**ADDENDUM NO. 1**  
**For**  
**18-0057-UT MS WRF Blend Tank Mixer**

**ADDENDUM #01 - Responses to Bidder Questions      09/28/2020**

MS WRF BLEND TANK  
MIXER PROJECT  
SLUDGE TANK PLAN AND SECTION

## Photographs

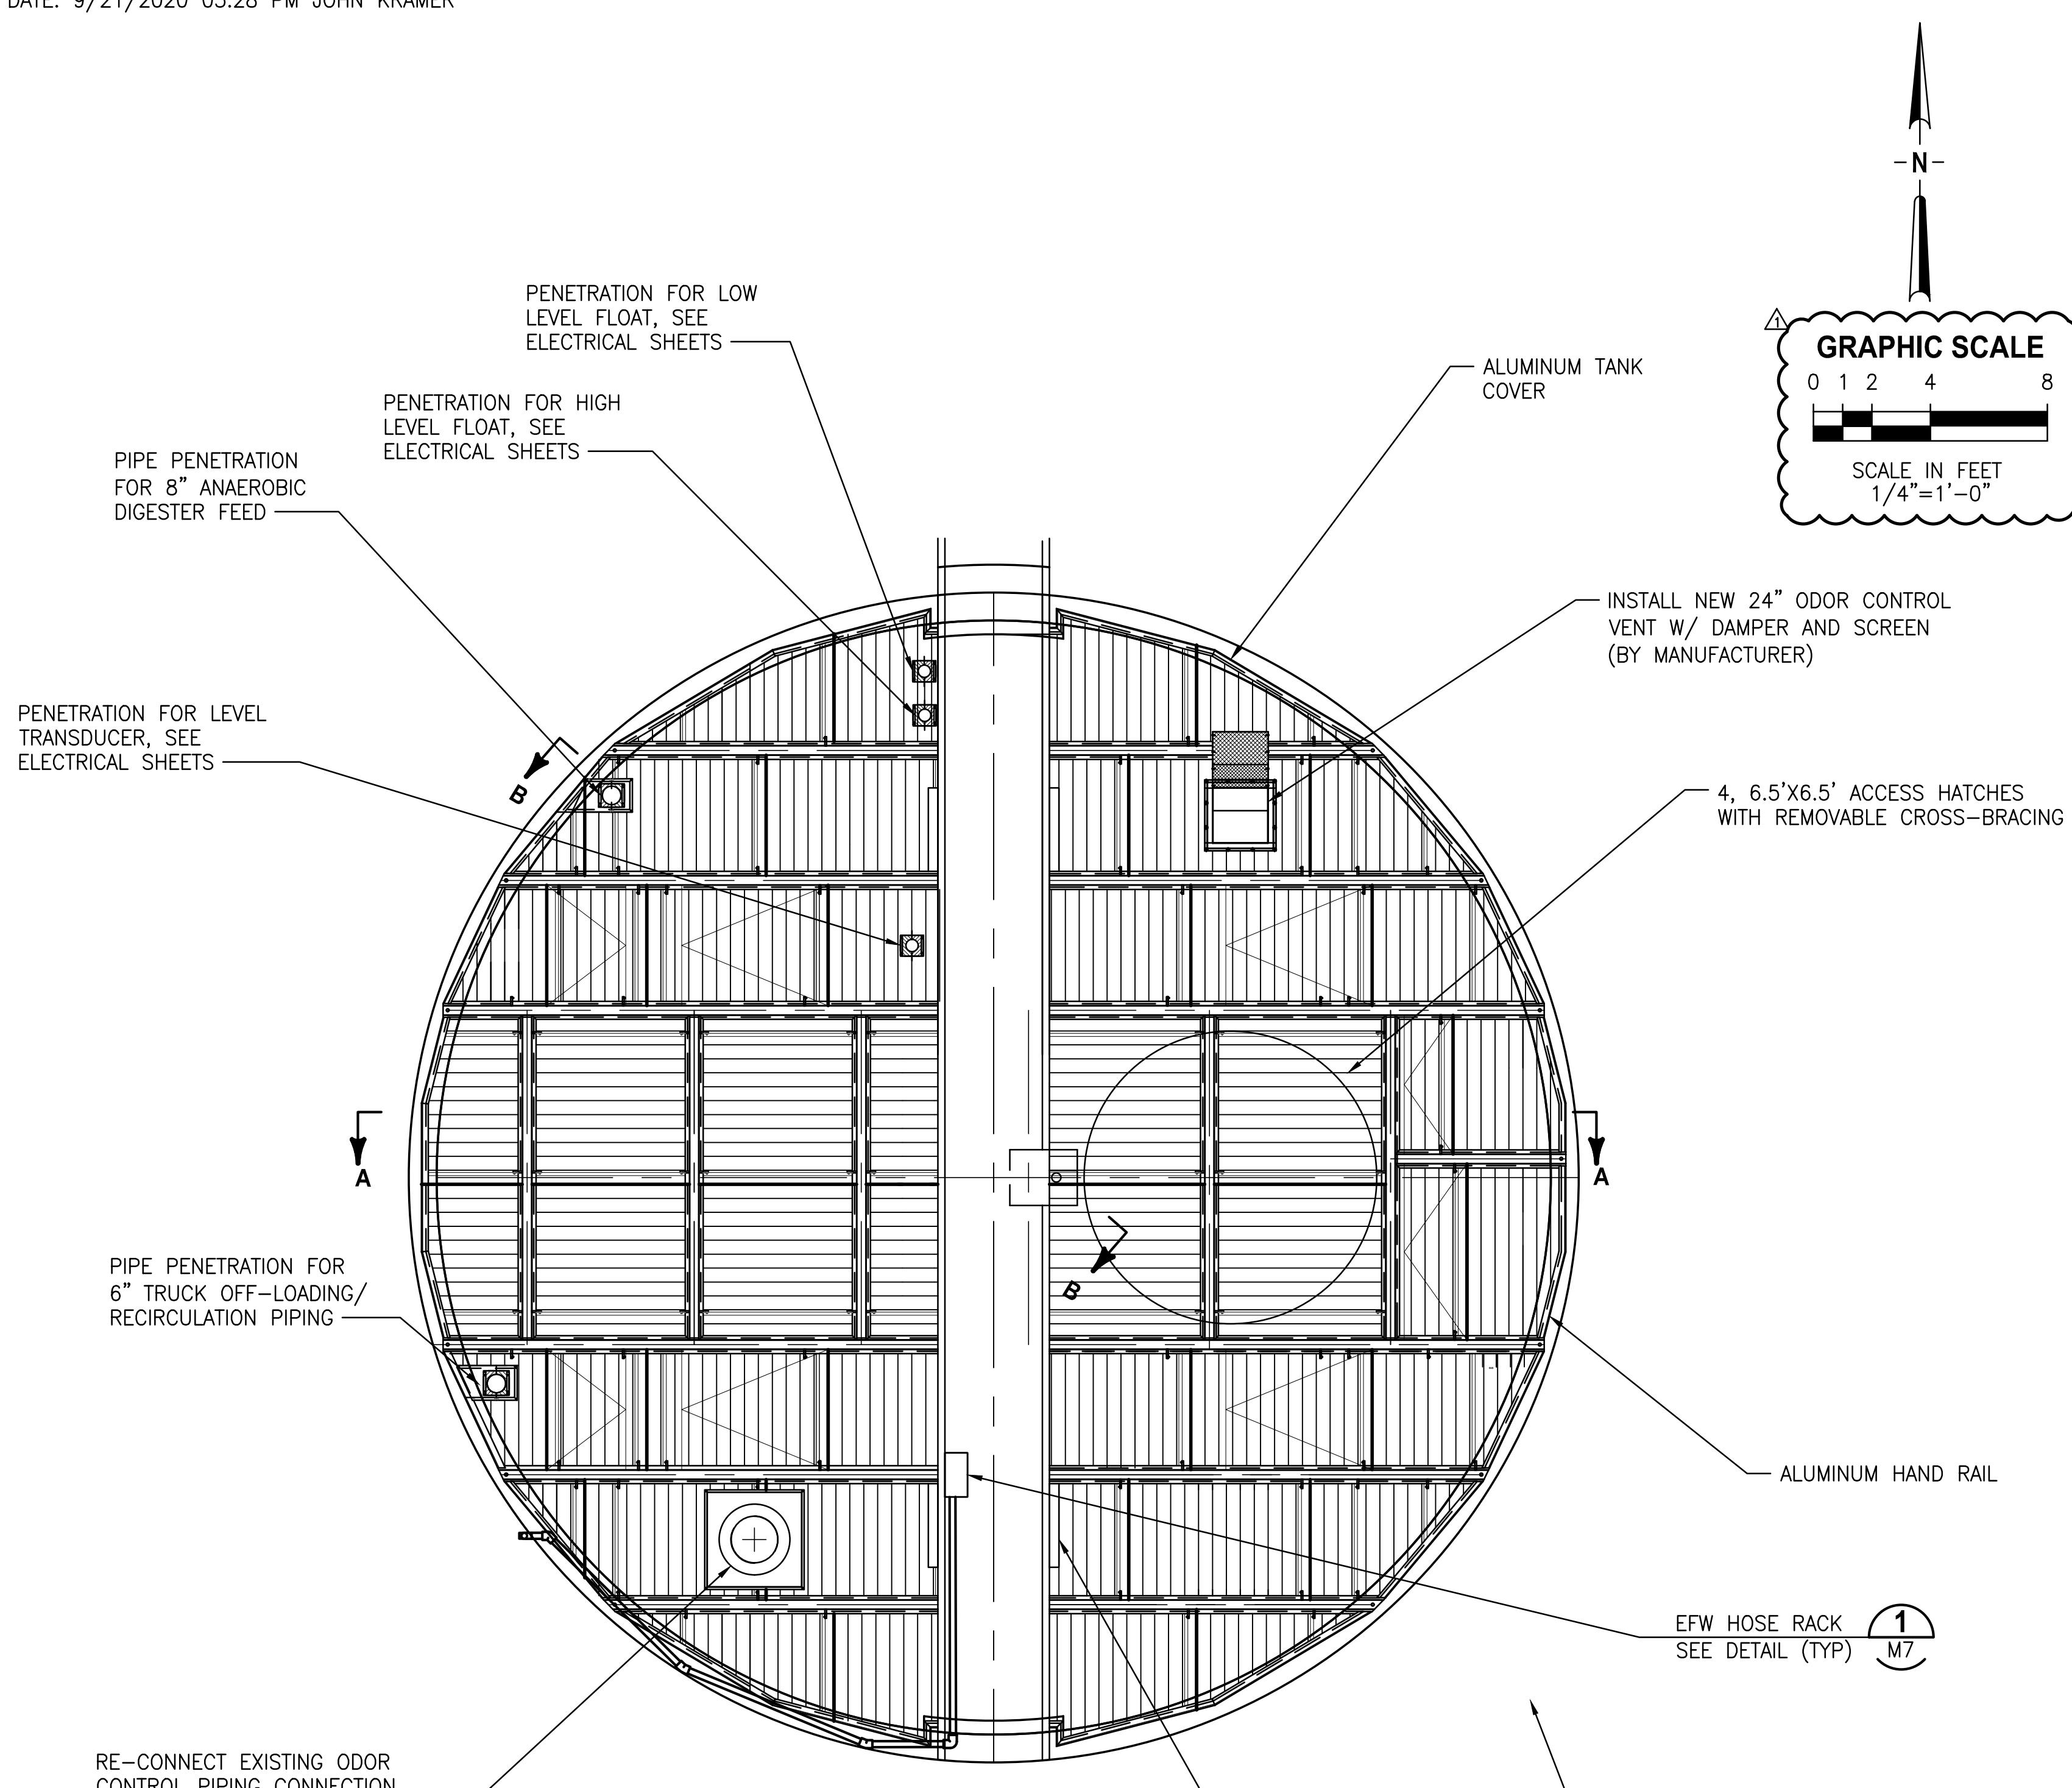
Question 1: A) The scale given on mechanical drawings (M1 to M9) seems to be wrong. The given dimensions on mechanical drawings don't match with the scale.

- a. The listed scales on Sheet M-3 (3/8"=1'-0") are dependent on the Drawings being a Full-Scale / Full Size 22" x 34" set. Confirm scaling on Sheet M-3.
- b. The Plan view on Sheet M-4 is herein revised to depict the correct scale and Tank Diameter. These sheets were intended for referencing elevations.

△ ADDENDUM #1 ADJUSTED SCALE  
REVISION BY DATE
